IFB No. **17-15 Auburn High School Softball Field**

RE: **ADDENDUM NO. 1**

ROCKFORD PUBLIC SCHOOLS 17-15 Auburn High School Softball Field

JOB NUMBER:
 16-727
 SHEET NUMBER:
 7 of 13

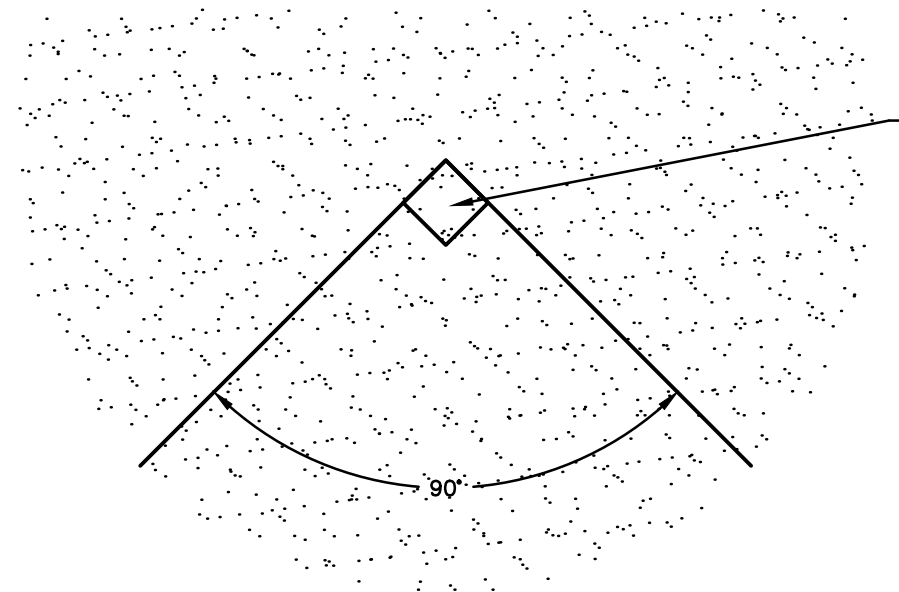
1. Sheet 7 of 13 – Grading/slope of outfield has been revised to 1.5%.
2. Sheet 9 of 13 – Clay blocks under infield mix at batter and catcher boxes have been added to the plans and a note regarding material and costs has been added to the plans.
3. Sheet 11 of 13 – Foul pole supplier note has been revised to include additional supplier.

REVISIONS		
REV. NO.	DESCRIPTION	DATE
1	REVISION TO OUTFIELD GRADE	10/6/16

HOME PLATE
SCALE : 1/4" = 1'-0"

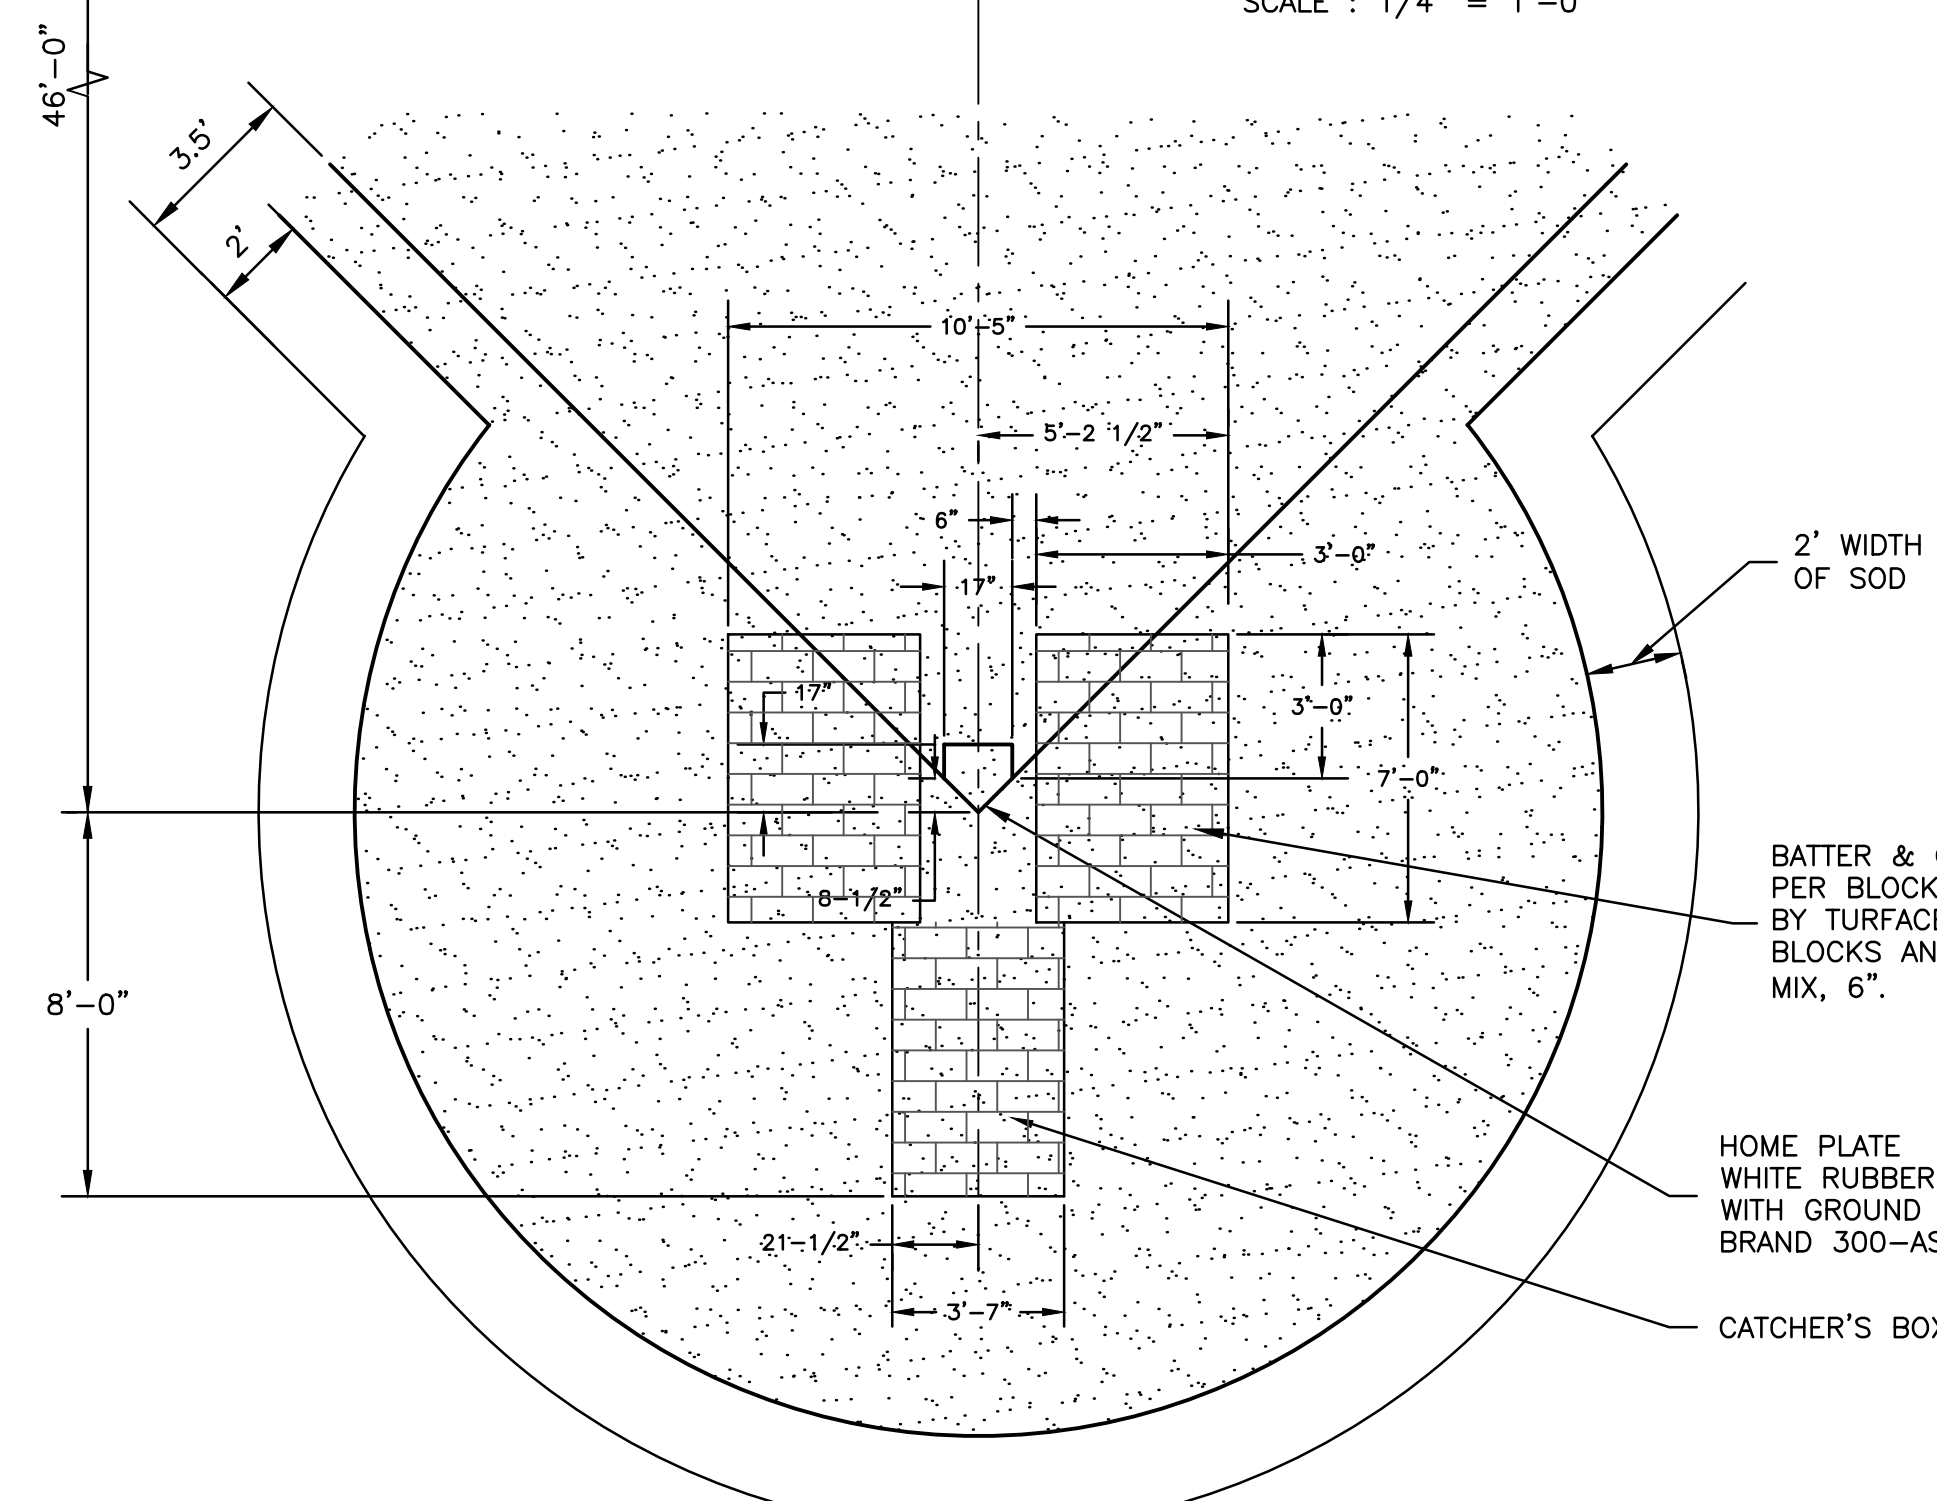
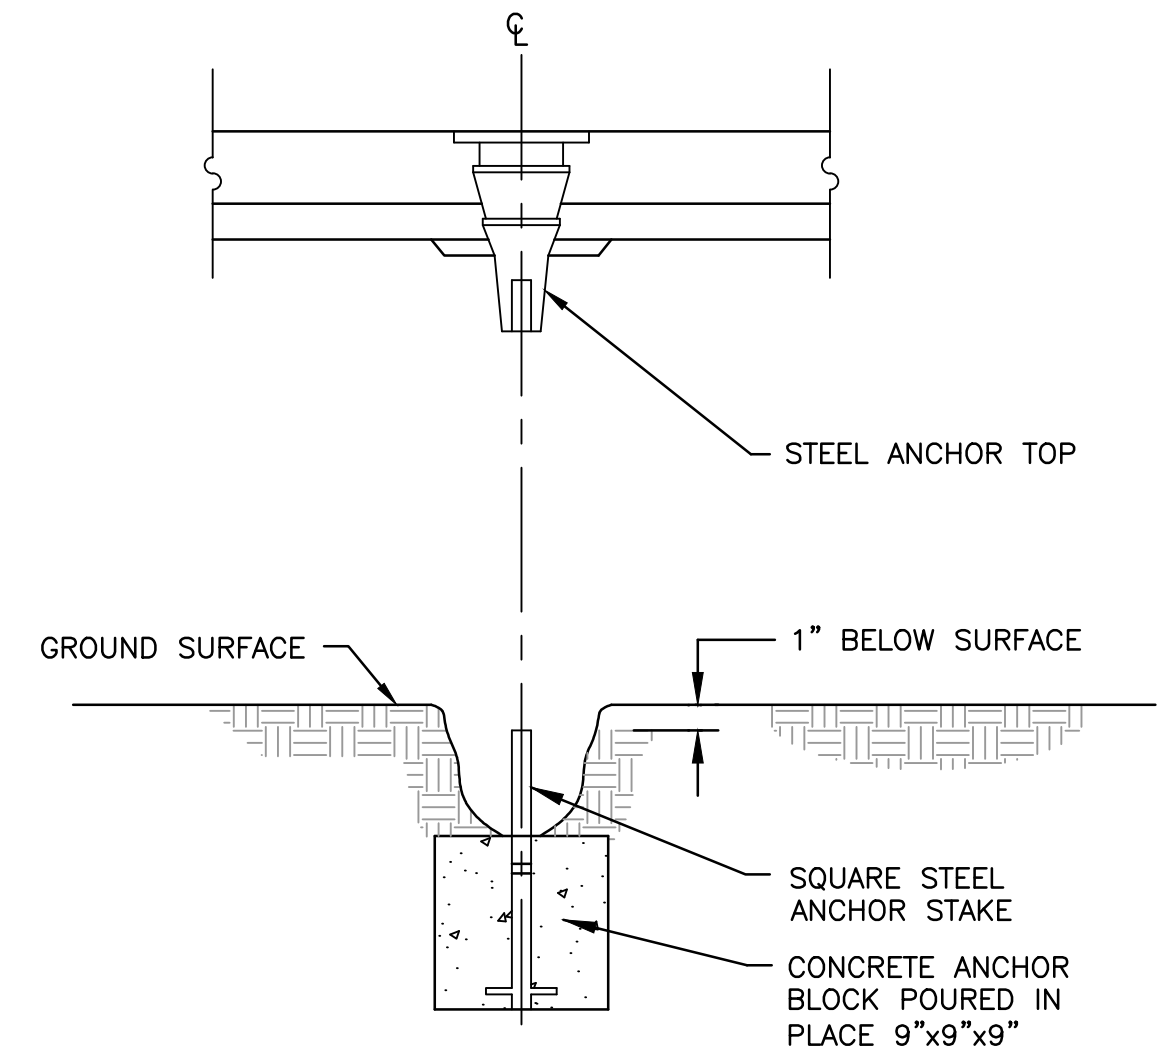
REVISIONS		
REV. NO.	DESCRIPTION	DATE
1	ADDITION OF CLAY BRICK TO BATTER/CATCHER BOX	10/6/16

BATTER & CATCHER BOXES TO HAVE CLAY BLOCK INSTALLED BELOW INFIELD MIX SURFACE PER BLOCK MANUFACTURER RECOMMENDATION. MOUND MASTER BLOCKS AS MANUFACTURED BY TURFACE ATHLETICS OR APPROVED EQUAL. COLOR OF BLOCKS TO BE GRAY. COST FOR BLOCKS AND INSTALLATION SHALL BE INCLUDED IN THE CONTRACT UNIT PRICE FOR INFIELD MIX, 6".

FOUL POST DETAIL
N.T.S.

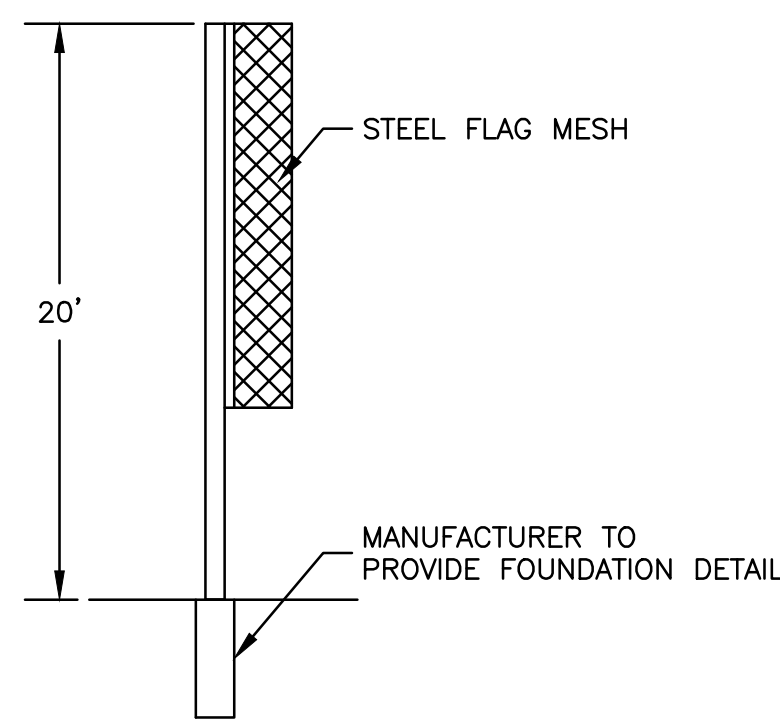
1. A revision to the fence crown material was suggested to increase the lifespan and the material spec was given to RPS for review.
 - a. RPS will review and any change to the fence crown material type will be addressed prior to bid via formal addendum.
2. Request was made to revise the plan details for the fence post foundations as money could be saved by doing this.
 - a. No change to the plan details regarding the fence post foundations will be made and the foundations are to be installed according to the details shown.
3. Request was made to revise foul pole manufacturer to allow supplier of bases and other amenities to supply the foul poles.
 - a. This will be addressed in the forthcoming addendum.

REVISIONS		
REV. NO.	DESCRIPTION	DATE
1	ADDITION OF SECOND FOUL POLE SUPPLIER	10/6/16

FOUL POLE SUPPLIER
PARK & RECREATION
6701 SEYBOLD ROAD
MADISON, WI 53719
(608) 274-0223

OR

BEACON ATHLETICS
8233 FORSYTHIA ST., STE 120
MIDDLETON, WI 53562
(800) 747-5985
